Confirmation Letter

We, Grandstream Networks, Inc., hereby declare that we have a product named as Carrier-Grade HD IP Phone, model: GRP2624 Pro/ SPE-GRP2624 Pro, FCC ID: YZZGRP2624PRO.

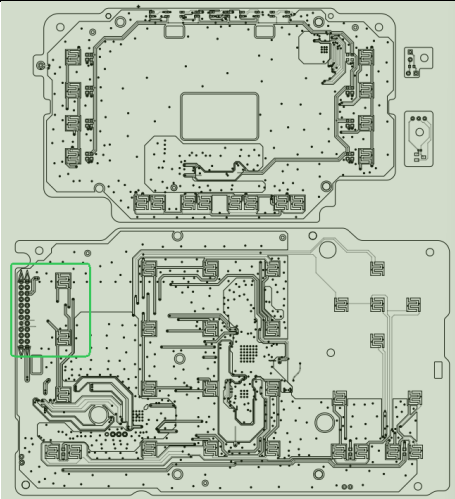
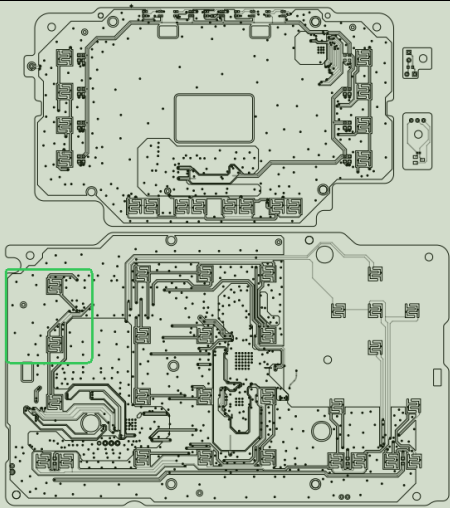
Models	GRP2624 Pro	GRP2624 Pro	SPE-GRP2624 Pro
Lens screen printing			
KP board version	v1.2(uses pin headers)	v1.3(Change to FPC cables, and components need to be moved from the original v1.2 version to create space for the FPC socket design.The change not affect the RF performance)	
Top

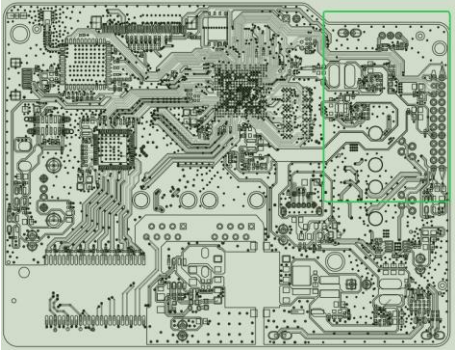
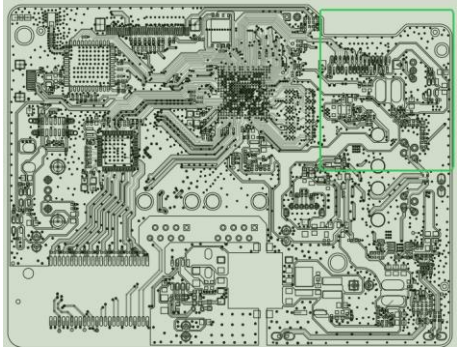
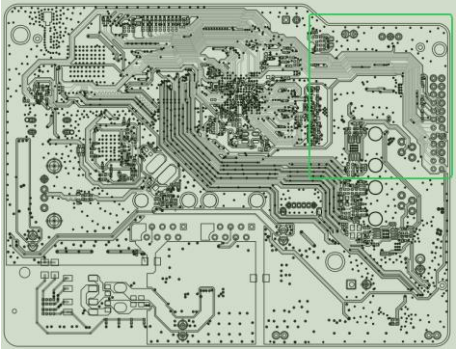
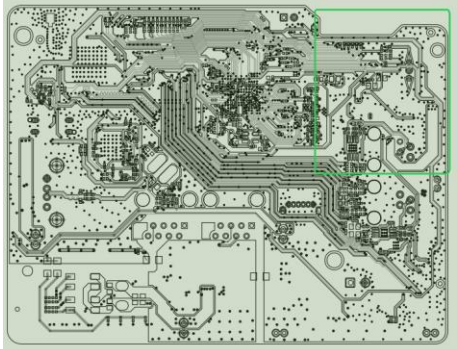
Models	GRP2624 Pro	GRP2624 Pro	SPE-GRP2624 Pro
MB board version	v1.2(uses pin headers)	v1.3(Change to FPC cables, and components need to be moved from the original v1.2 version to create space for the FPC socket design. The change not affect the RF performance)	
Top			
Bottom
